City of Sandy

Planning Commission Meeting

Meeting Date: Monday, January 28, 2019

Meeting Date: January 28, 2019
From James Cramer, Associate Planner
SUBJECT: 18-051 VAR RV Storage Setback Variance

Site plan

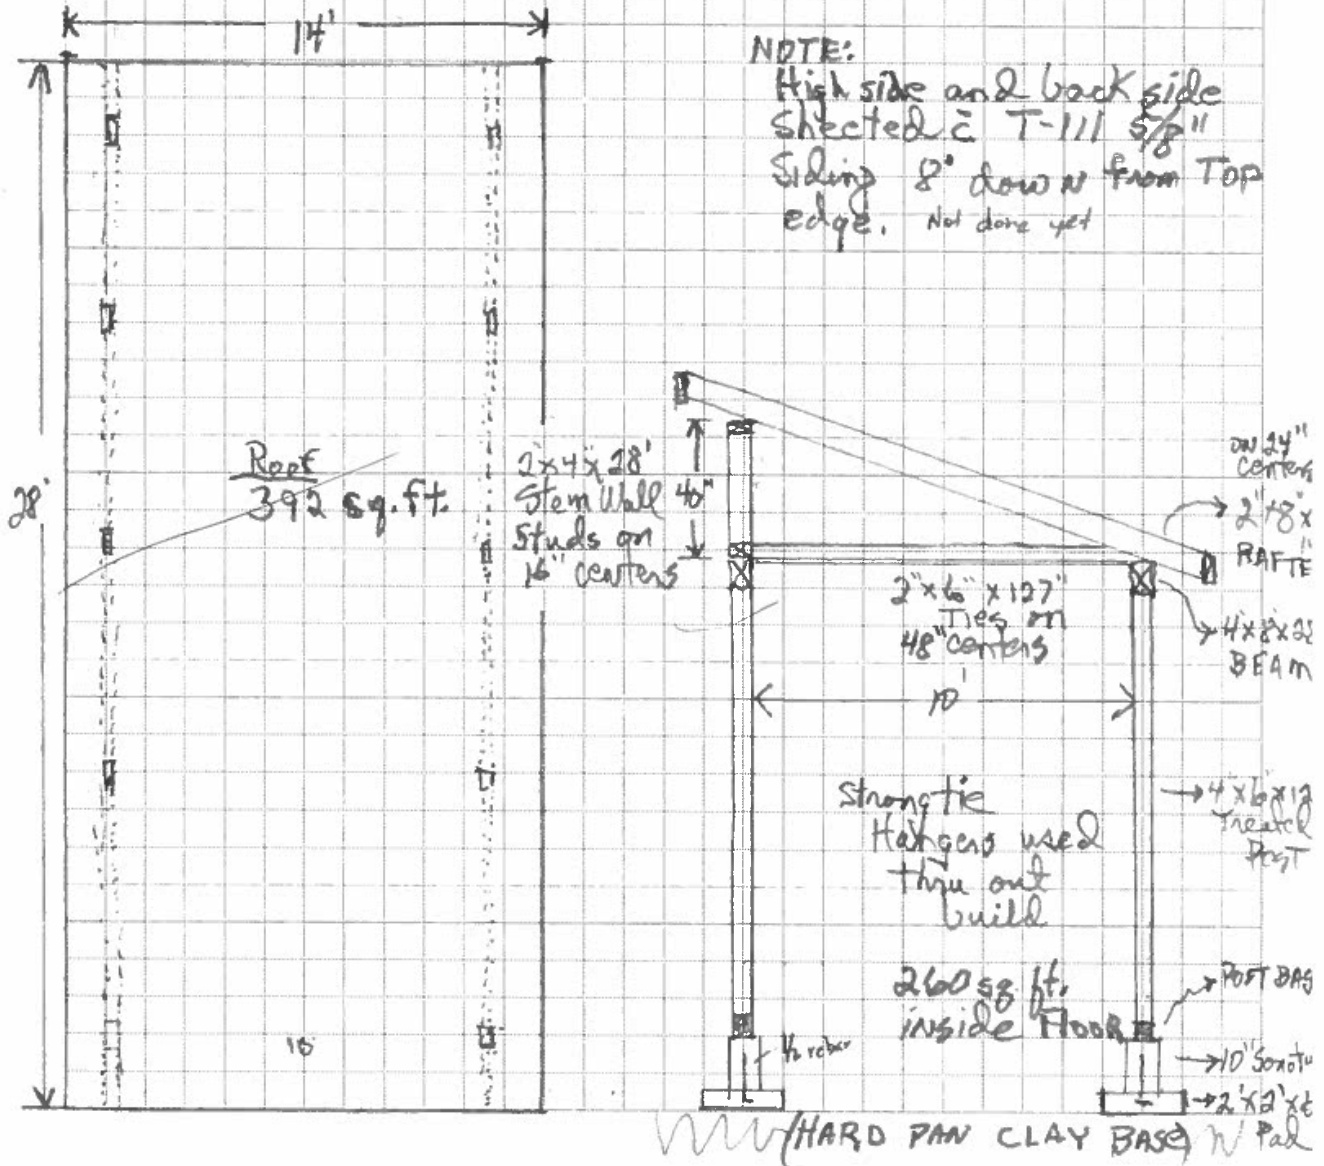
*Oregon Residential Specialty Code (ORSC) R302.1 identifies that garage walls or residential building walls less than 3 feet from a property line are required to comply with TABLE R302. The structure is proposed to be 2 feet (19 inches to roofline) therefore, if approved, the building **shall have a minimum of 1-Hour fire-rated construction.** Additionally, if the walls are less than 2 feet of the property line, then the maximum roof eave projections (including gutters) cannot exceed 4 inches. **The applicant shall verify the distance between the north façade and property line and adjust the eave according to ORSC standards prior to approval of a building permit.***

RECOMENDATION: *The Special Variance being requested is located on private property at the rear of the subject property with no other structures in close proximity. While the structure is proposed a short distance to the north property line, the ORSC identifies means to help mediate potential risks to neighboring properties which are covered within the conditions below. The intention of this code requirement is to provide a predictable set of development standards to promote open space on private property and create a buffer for fire separation. Additionally, the applicant proposes incorporating additional design elements to enhance the structure's facade and function to ensure it does not negatively affect neighboring properties or the aesthetic integrity of the neighborhood. **Staff recommends the Planning Commission approve the requested special variance to reduce the side (north) yard setback to 2 feet with the following conditions:***

RECOMENDATION: *The Special Variance being requested is located on private property with no other structures in close proximity. The intention of this code requirement is to provide a predictable set of development standards to promote open space on private property and create a buffer for fire separation. Additionally, the applicant proposes incorporating additional design elements to enhance the structure's facade and function to ensure it does not negatively affect neighboring properties or the aesthetic integrity of the neighborhood. Staff recommends the Planning Commission approve the requested special variance to reduce the rear (east) yard setback to 3 feet 5 inches with the following conditions:*

- 1. *Prior to building permit approval, the City shall contact NW Natural Gas, Portland General Electric, Wave Broadband and SandyNet and provide a two-week comment period for agencies to respond with any conflicts associated with the proposed structure's encroachment into the recorded PUE.***

- 3. *The applicant shall use a minimum 1-Hour fire-rated wall for the area of the structure located within 3 feet of the north property line as well as verify the distance between the north façade and property line and adjust the eave according to ORSC standards prior to approval of a building permit.***

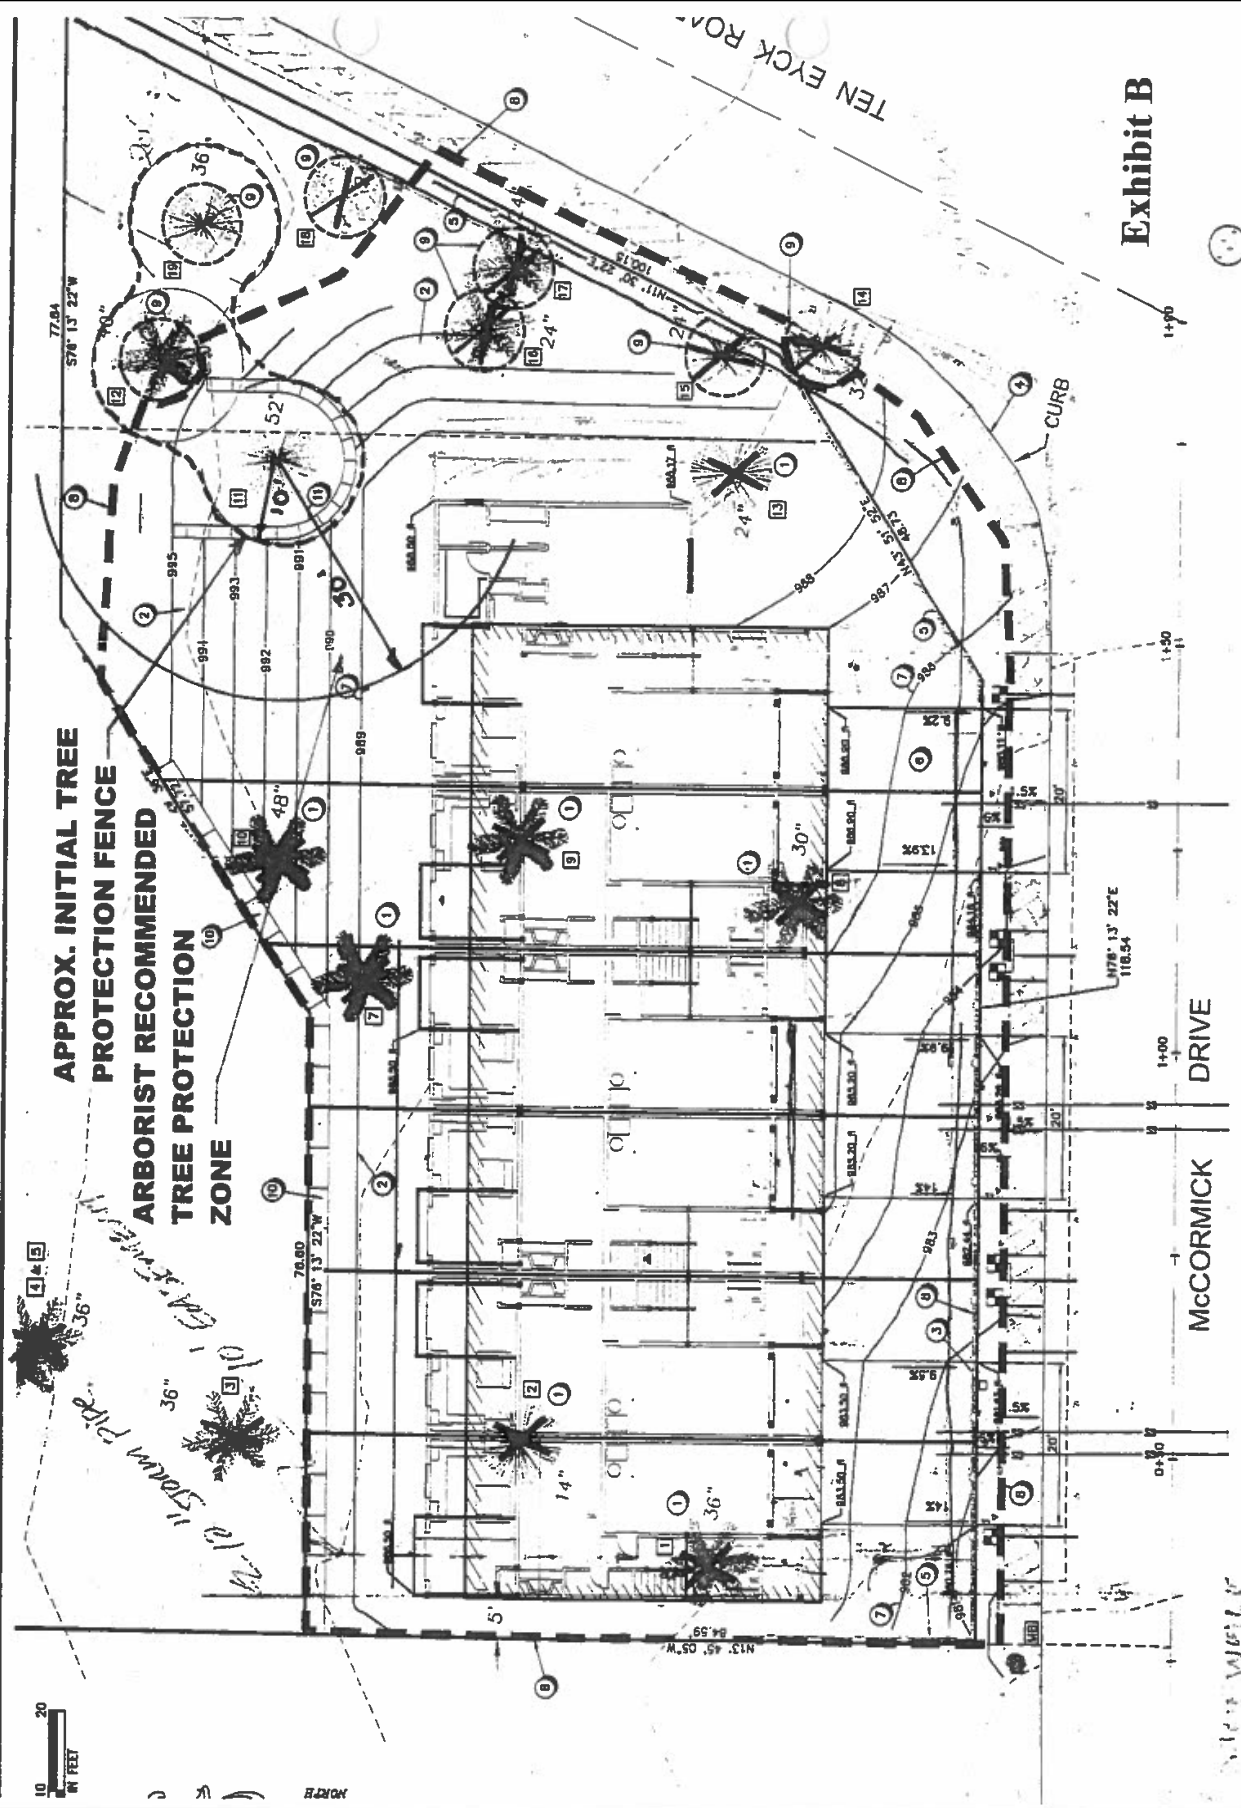
Per the Site and Stormwater Plan, sheet 3/10, tree # 1 will be less than 8.5 feet away from a planned retaining wall; tree #2 will be less than 11 feet from the north corner of an underground water detention facility; and tree #3 will be less than 10 feet from the north side of the detention facility.

Tree #1 is 60-inches diameter tree as measured at 4.5 feet above ground. With a tree 60 inches in diameter no construction activity should come within 30 feet on one of the tree's sides, 60 feet on the other sides of the tree. The plan for the project indicates a new wall will be installed

Tree # 2 is 47-inch diameter Western red cedar (*Thuja plicata*) at 4.5 feet above ground. The guidelines would indicate that no construction should come within 23.5 feet on one side of the tree. However, as this tree is to the north of tree # 1, the spread of its roots is limited to the south/southwest due to the presence of the roots from tree #1. It is unlikely that tree #2's roots will be impacted by the wall construction as long as the eastern side of the wall is modified to not extend to the north/northeast. However, the construction of the storm detention facility will impact the tree on its southeast side within 11 feet of the tree's center. This distance is less than 3 times the tree diameter and too close to be sure that the construction won't severely impact its roots. There is a chance that the distribution of the tree's roots may not extend too greatly in the direction where the facility is to be located. However, to be sure that the excavation for the storm facility won't cause the loss of too many roots, the project arborist shall be on site during the excavation to document any roots encountered and guide the pruning of any roots large than one inch. If too many roots are encountered, the project arborist may have to recommend removal of the tree due to concerns of the tree's structural stability.

I recommend that tree # 1 be removed as the planned retaining wall is too close to it. In addition, trees # 2 and 3 should also be removed unless either the project arborist can confirm that critical roots are not impacted during the excavation for the installation of the improvements or the planned improvement are move further away from the trees.

- **The applicant shall update the plan set to detail a curb-tight sidewalk in the section where the proposed sidewalk encroaches within the CRZ of Tree #3 and shall submit to the City for review and approval. The applicant shall update the plan set to relocate other improvements, including the storm detention facility and PGE vault, as far**

- If the arborist finds that Trees #2 and #3 can be successfully retained then the applicant shall retain Trees #2 and #3. If the arborist finds that Tree #2 and/or Tree #3 cannot be successfully retained, the applicant shall submit a land use application for a Type III Tree Variance before Planning Commission and shall include an arborist report with an updated recommendation related to the removal of Tree #2 and/or Tree #3. The applicant shall also be required to pay a third party arborist review fee for any trees proposed for removal from the property in the future.
